City of
Richmond

Report to Development Permit Panel

File: DP 18-829236

Re: **Application by 1132865 BC Ltd. for a General Compliance Ruling at 7580 No. 1 Road (formerly 7464, 7480, 7500, 7520, 7540, 7560/7580 and 7600 No. 1 Road)**

Attachment # 4
APPENDIX 3
TREE MANAGEMENT PLAN

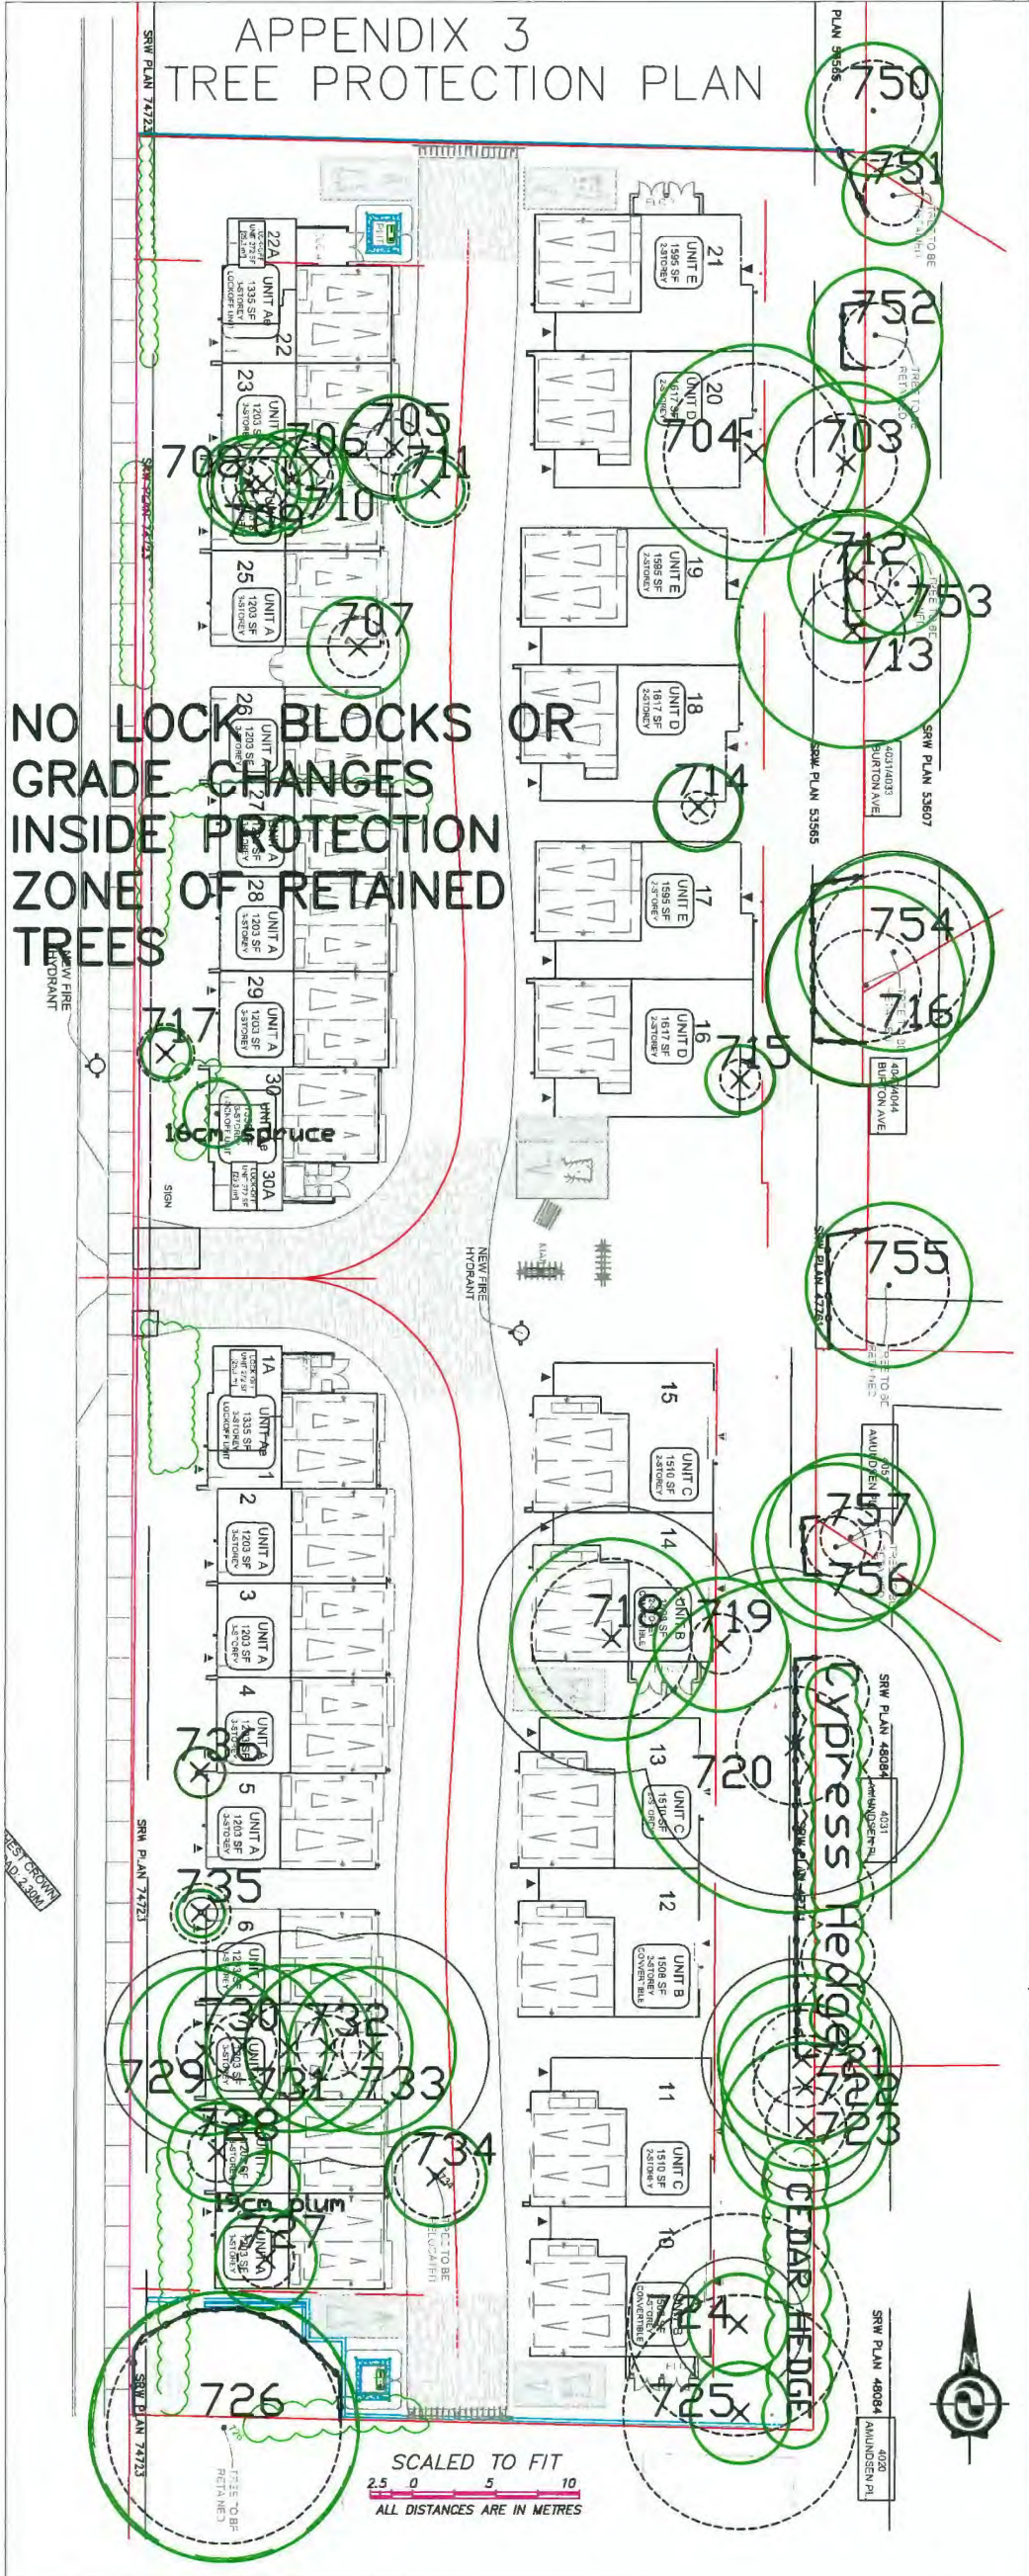
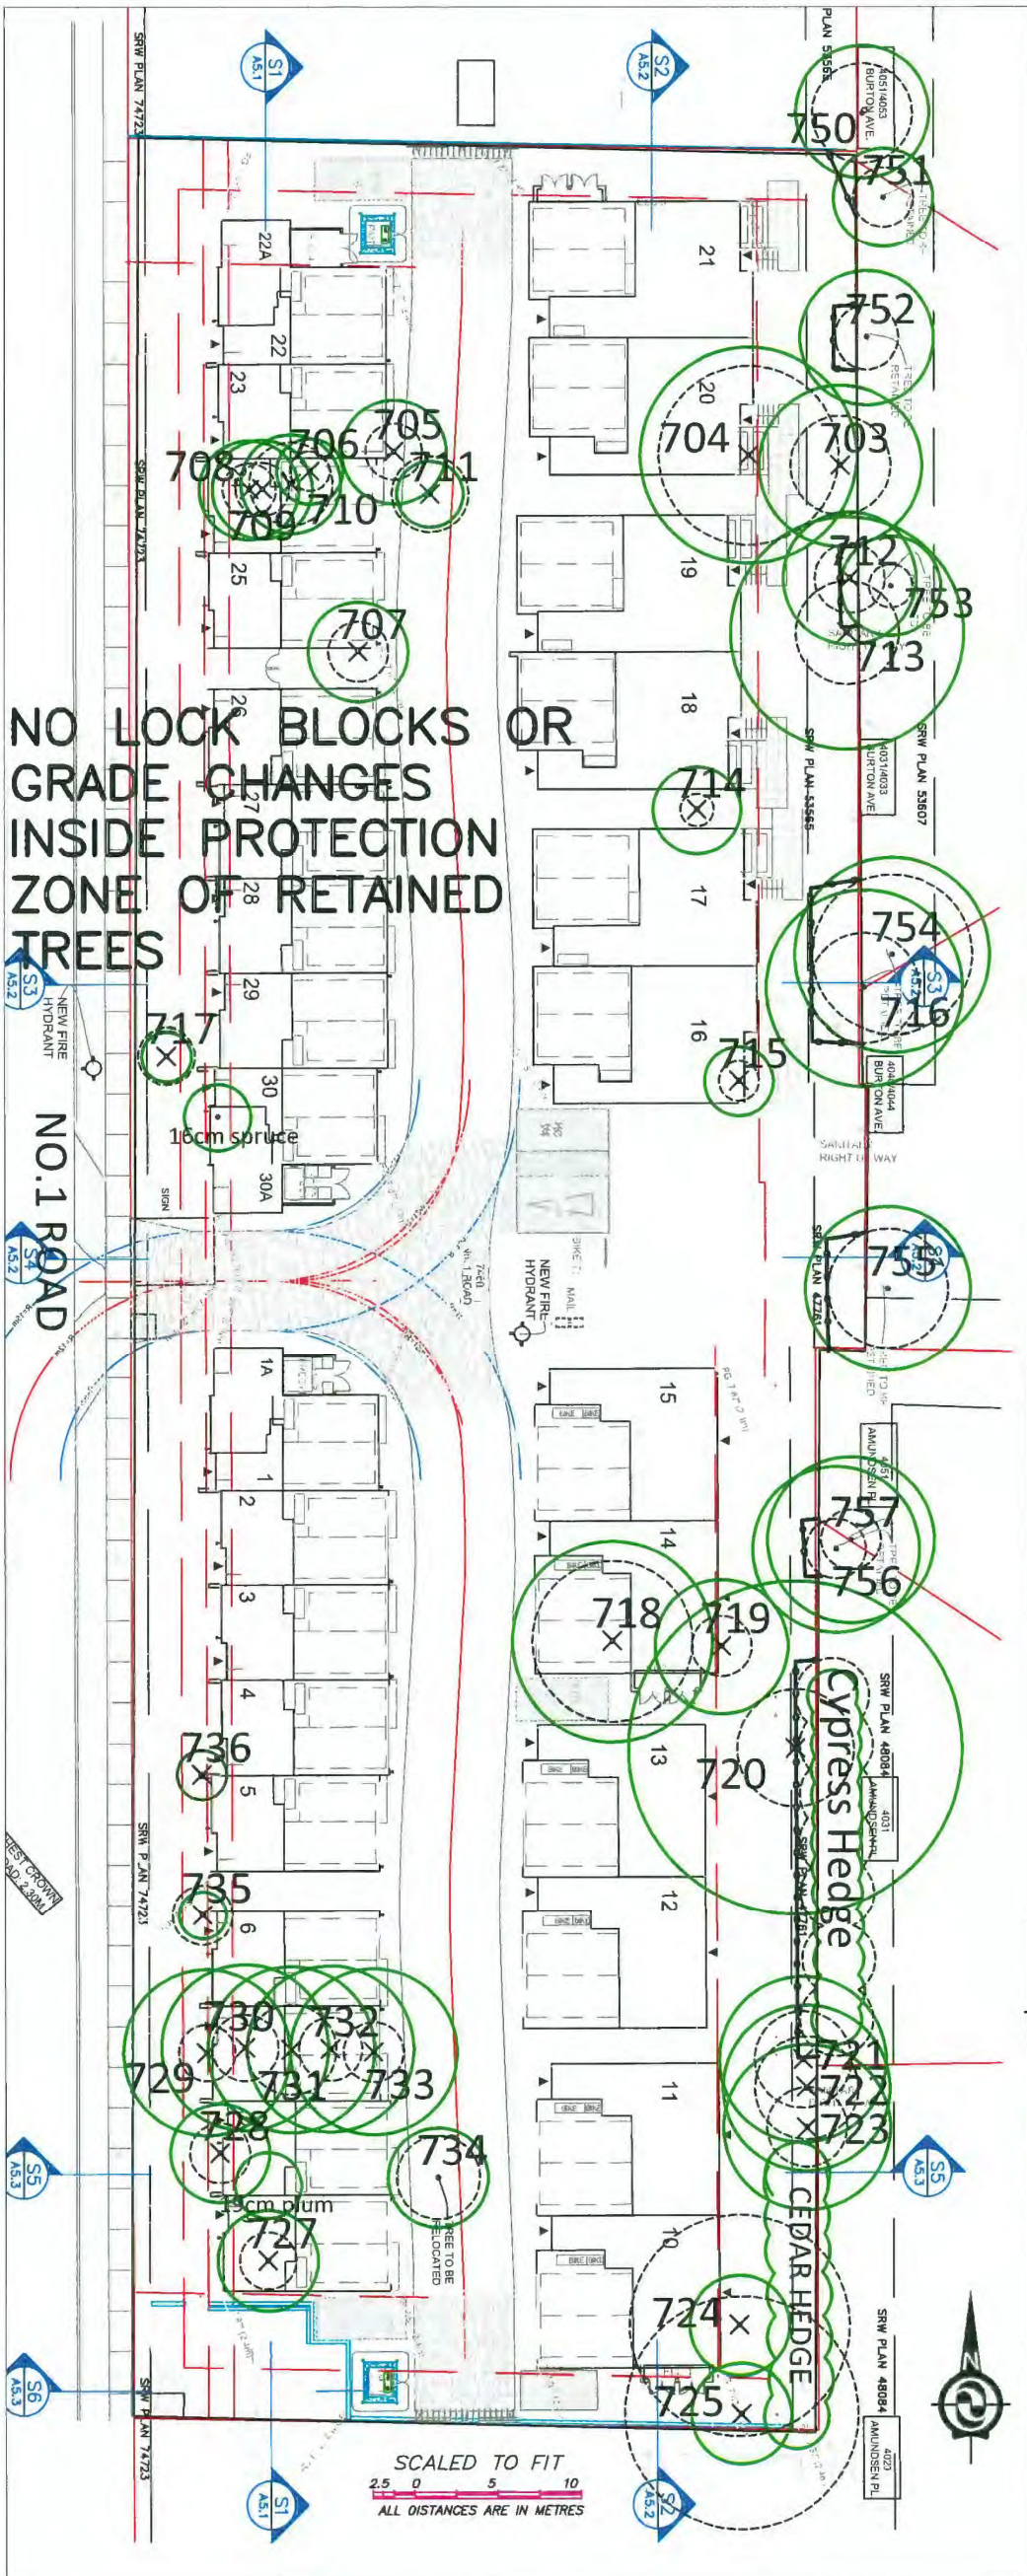
This General Compliance application is for a modification to the issued Development Permit (DP 18-829236) to address the deterioration and advanced state of irreversible decline of a tree (Tree Tag #726) that was to be retained. The proposed modification includes changes to the Tree Management Plan and Landscape Plan issued with the Development Permit (DP 18-829236).

- Despite all efforts to retain tree #726, the tree is not expected to survive. As a result, the applicant is seeking to remove the tree.
- As tree #726 is located along a shared property line, the neighbouring property owner has been consulted and provided written confirmation agreeing to the removal of the tree.

- To account for the required removal of the Sycamore maple tree (tag #726), the applicant proposes to:
 - Maintain the modified building setback established to retain the tree that was removed. This is in keeping with the City’s policy and practice.
 - Plant two large replacement trees (11.0 cm caliper Dawyck beech) in the southwest corner of the property, as shown in the revised Tree Management Plan and Landscape Plan (Attachments 4 and 5). This tree species was selected as it has a high likelihood of transplant success and will provide immediate visual impact at the site. The replacement trees are to be planted slightly north of the location of the original tree, and away from the proposed building to provide sufficient space for its growth.
